Planning Commission Meeting Minutes
Worcester Township Community Hall – 1031 Valley Forge Rd., Worcester, PA 19490
Worcester Township Planning Commission – Meeting Minutes - February 27, 2025

RE: 1038 Windy Hill Road – 2 Lot Subdivision
Minor Subdivision Plan Application
Bursich Project No.: MIK-01 / 208161.01

RE: SUBDIVISION PLAN/LAND DEVELOPMENT PLAN OF 1038 Windy Hill Road -
2 - Lot Subdivision

Layer List:
D21-09_Profile
Job No:
00-0606 D21
Plan Date:
JAN. 31, 2025
Sheet No:
9 of 17

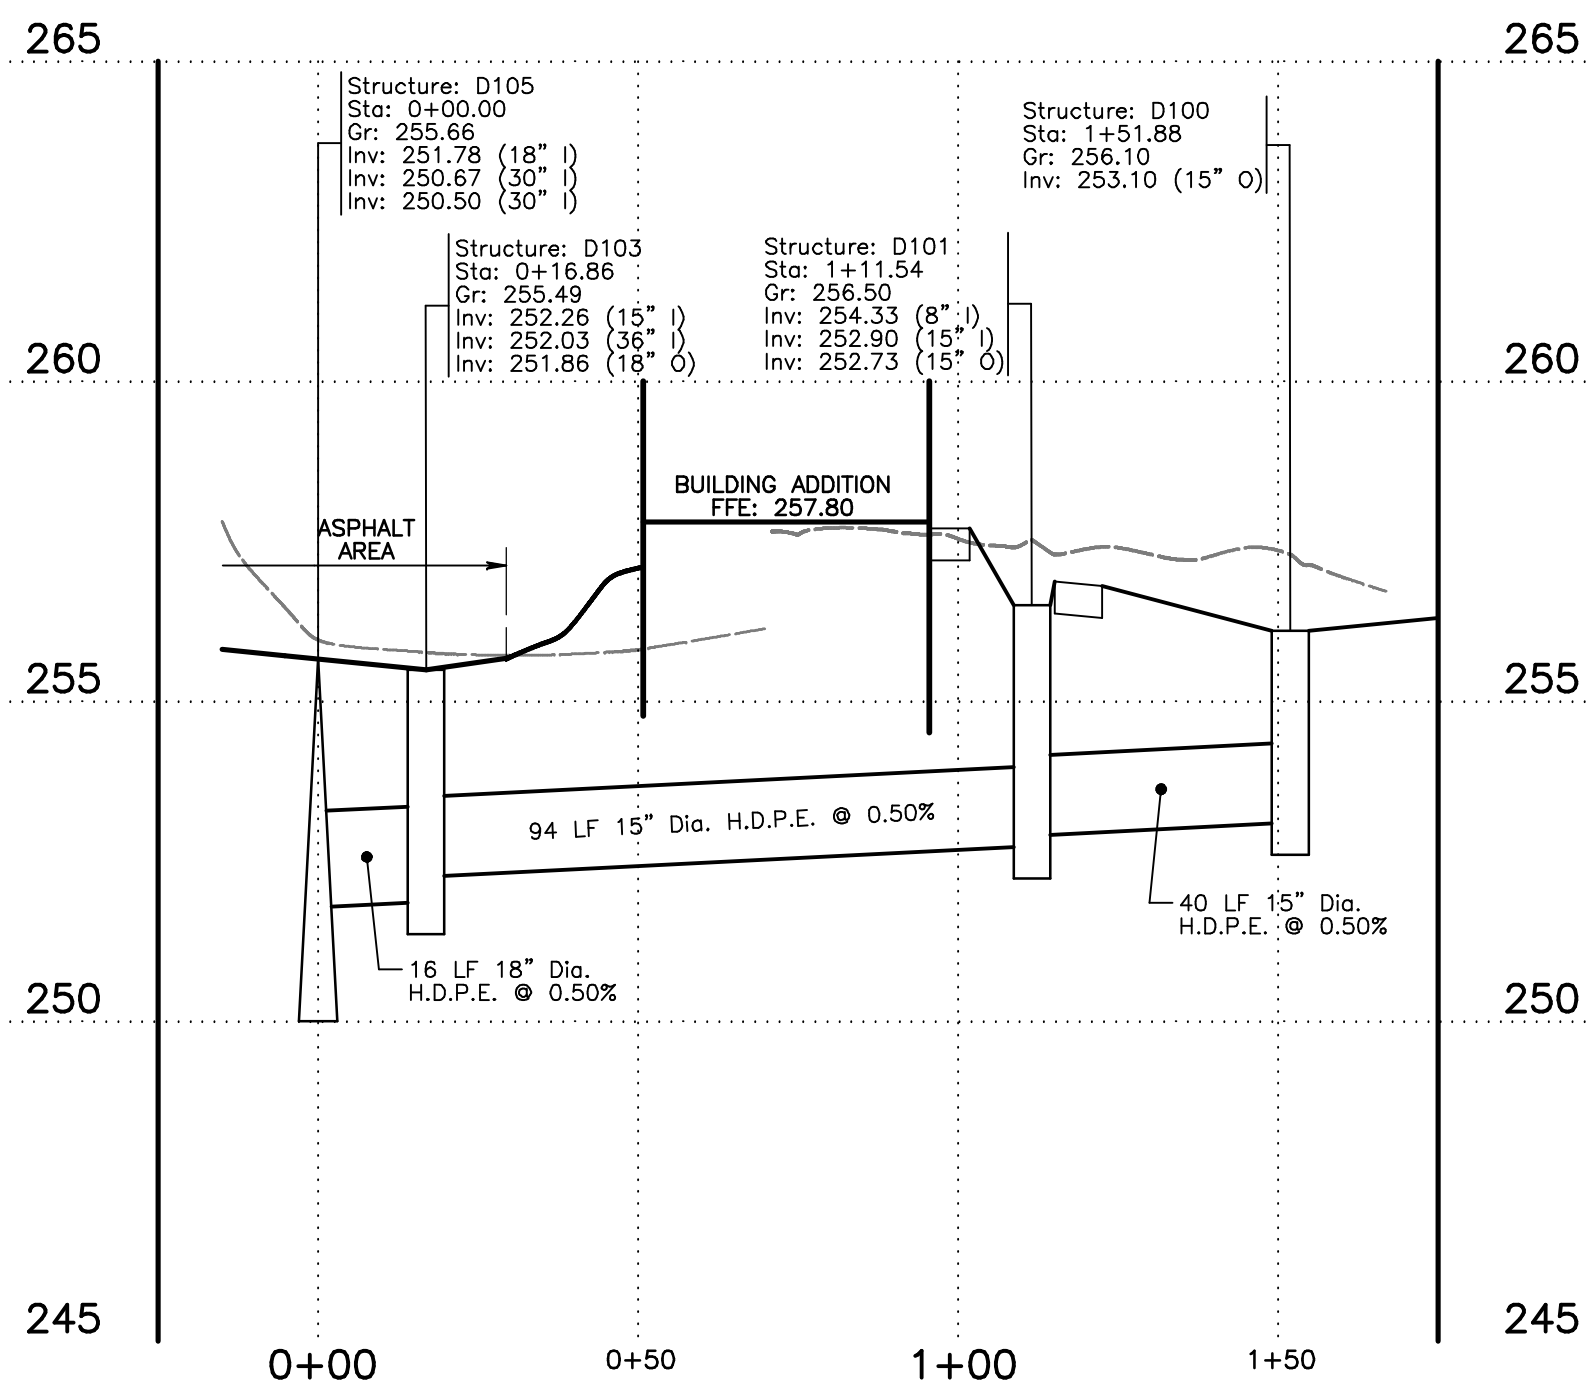
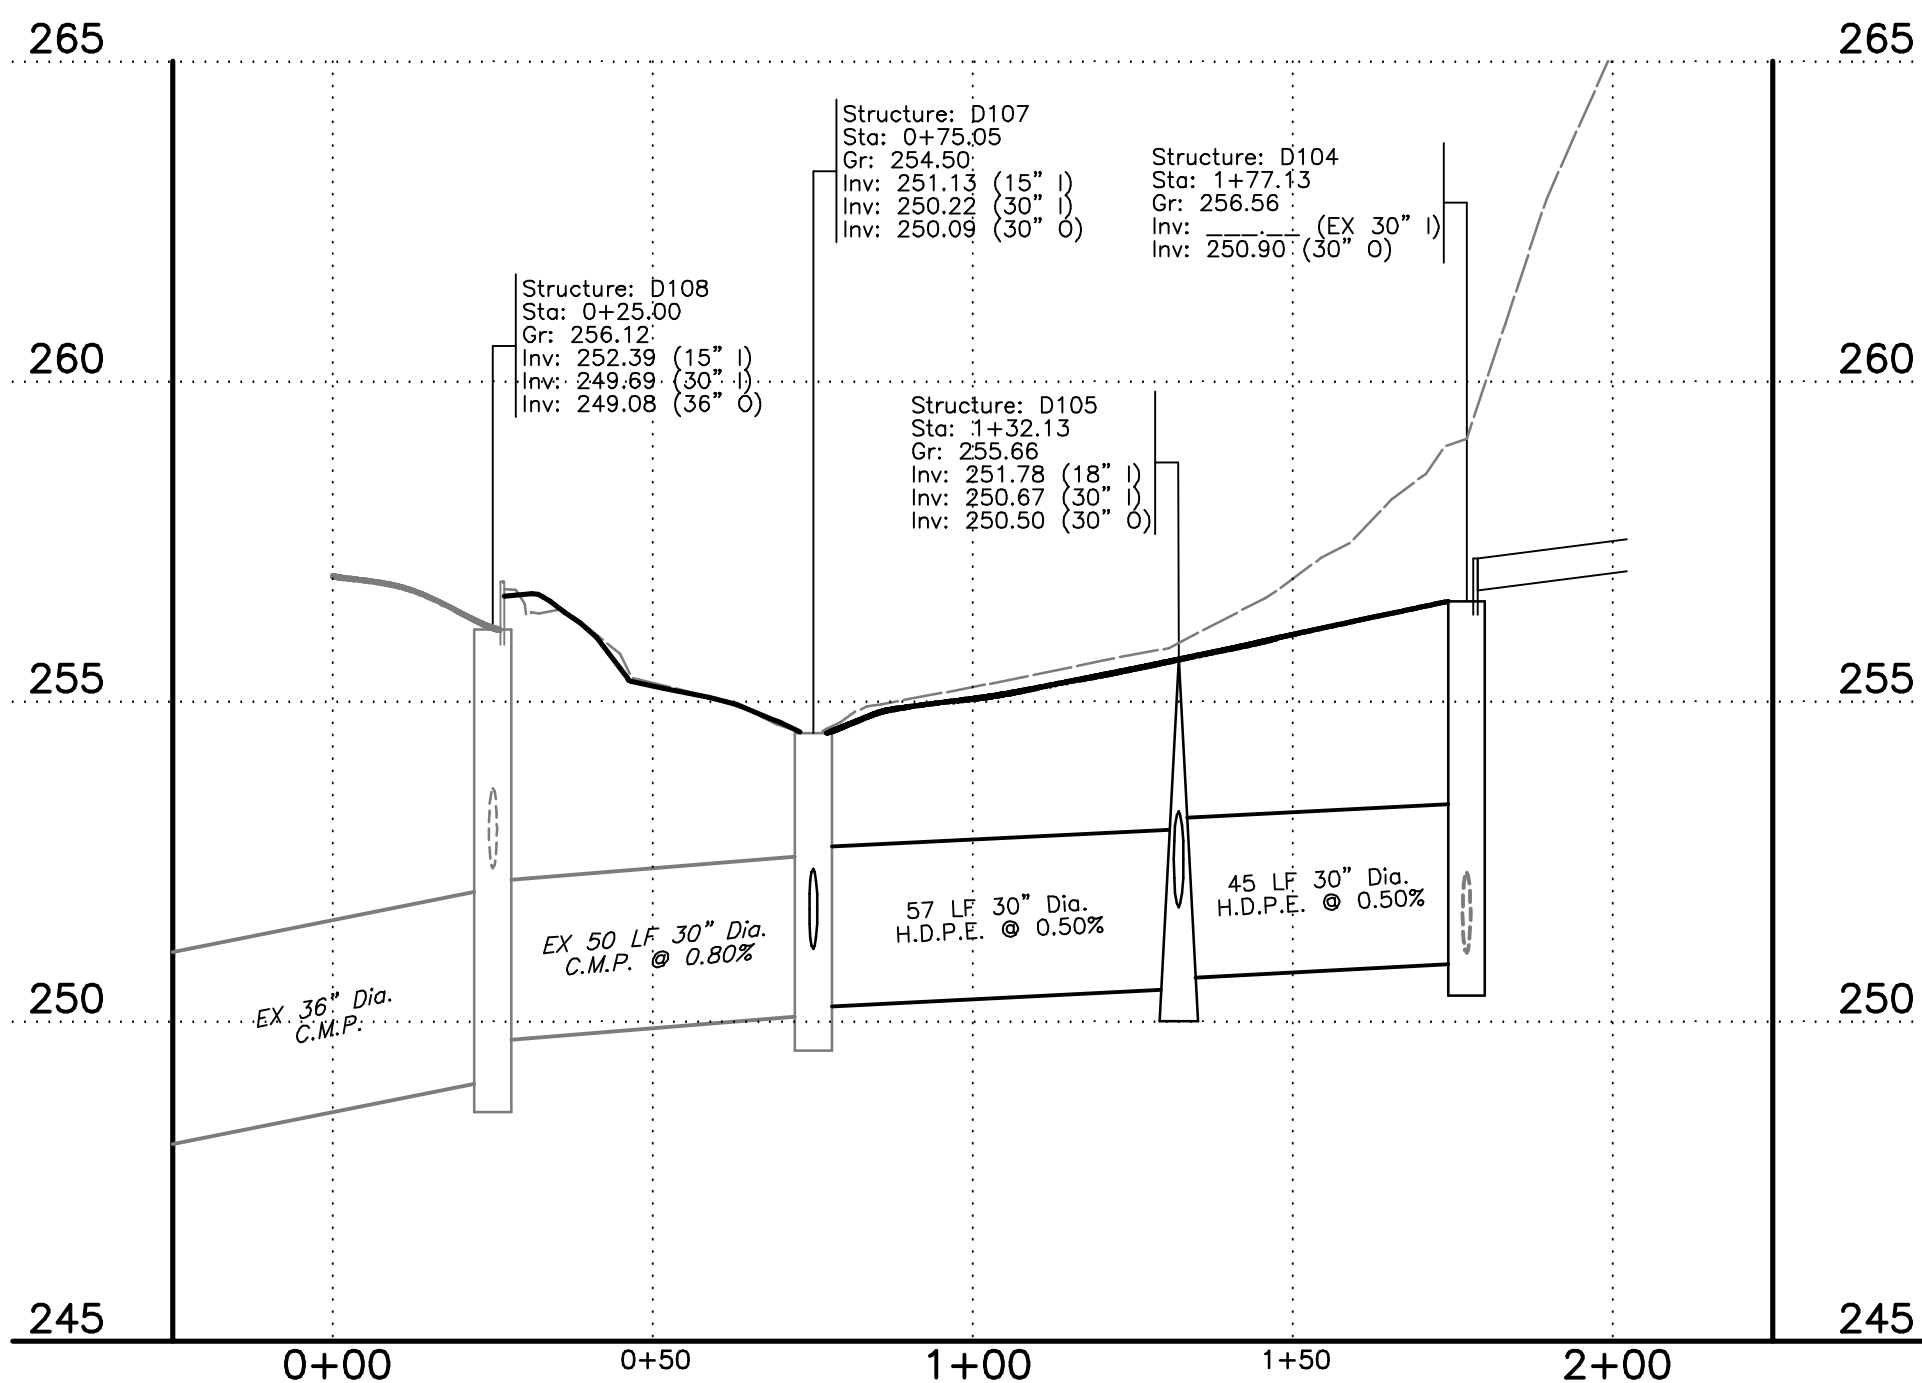
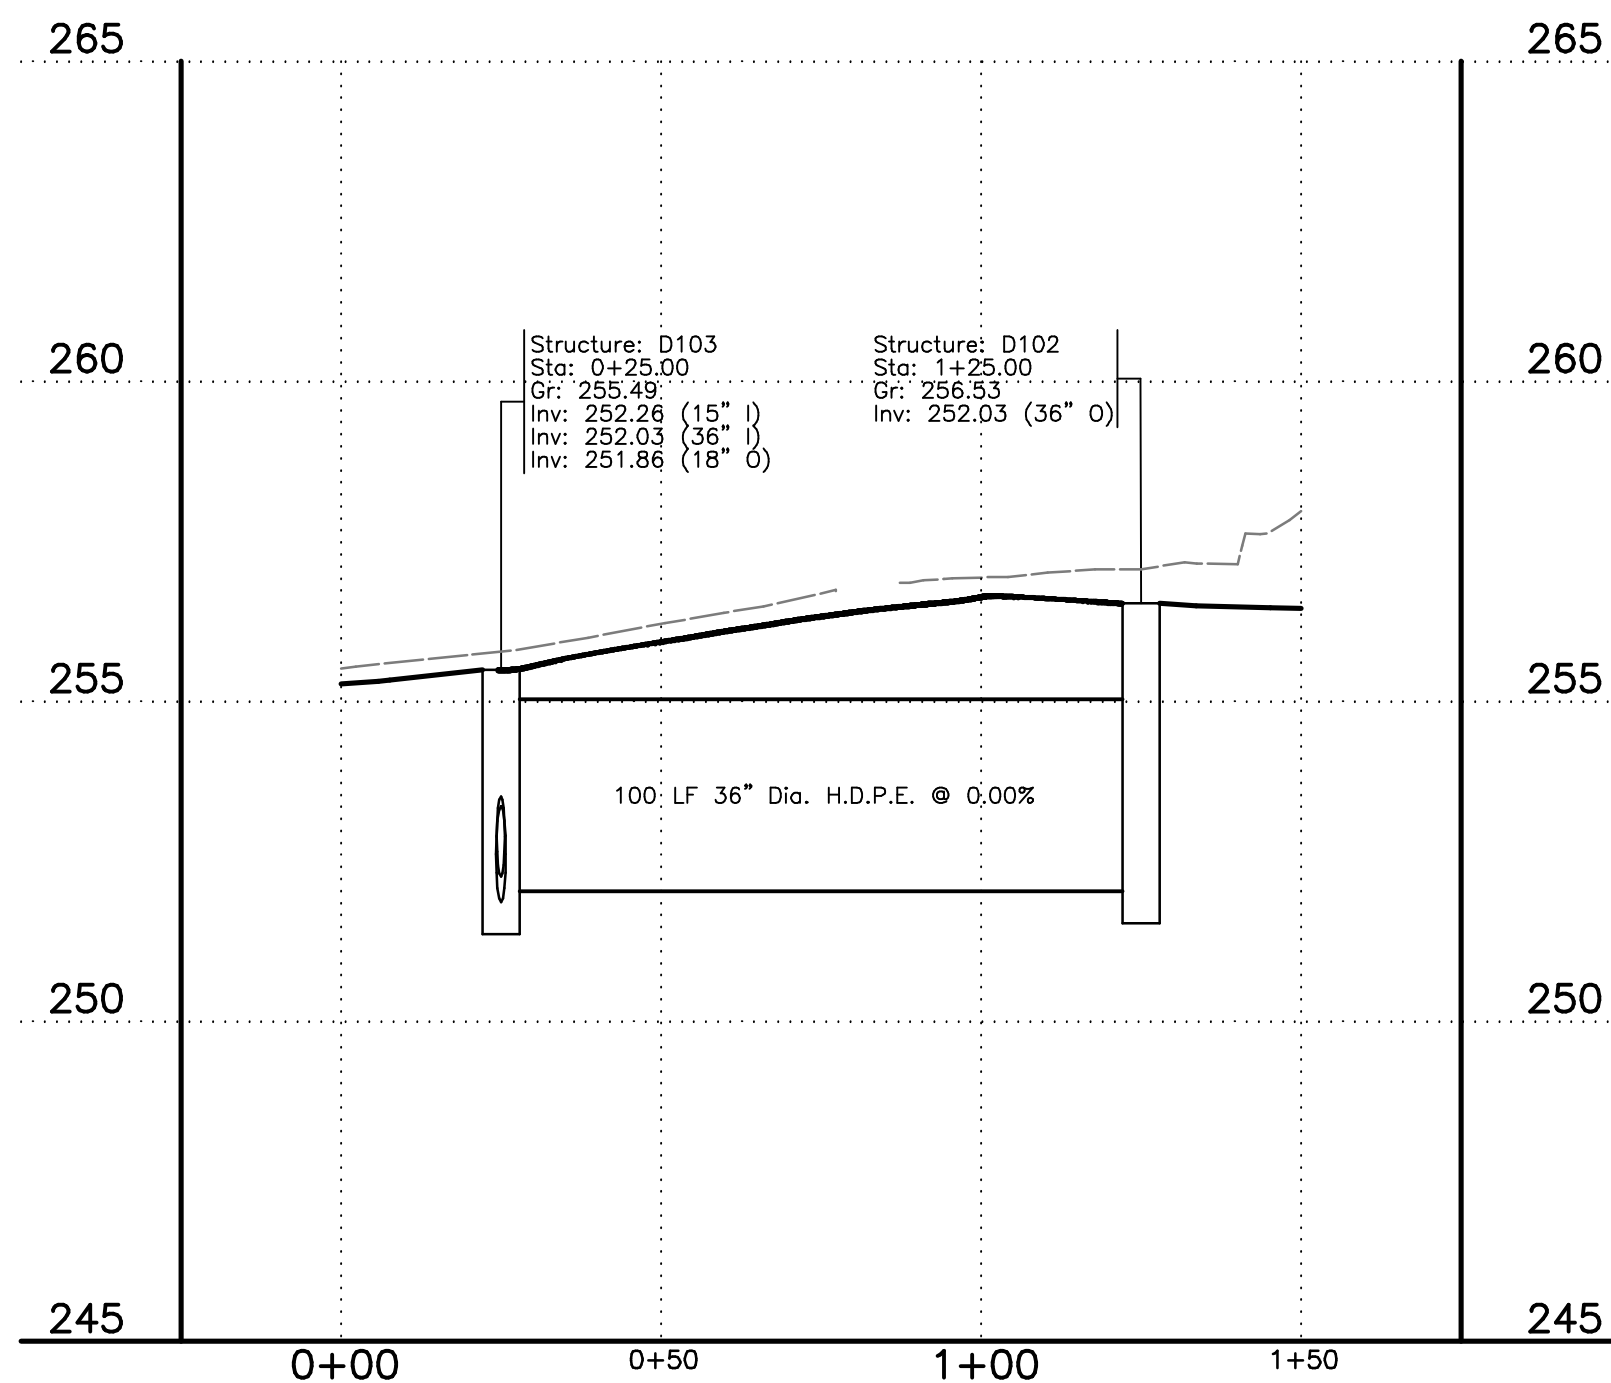
3. A detail and calculations pertaining to the seepage bed must be added to the plans.
4. On both Sheet 6 and Sheet 9, there is a missing invert for structure D104.

5. Sheet 6 has a rim elevation for Manhole D105 of 255.73 and Sheet 9 has a grate elevation of 255.66. The plans must be revised accordingly.

13. Additional spot elevations and grading must be added to the courtyard area.
14. Inlet D106 must be shown on the profiles on Sheet 9. (130-33.F.1)
15. Additional cover over pipe D101 – D100 is required. Further, this pipe shall be RCP.
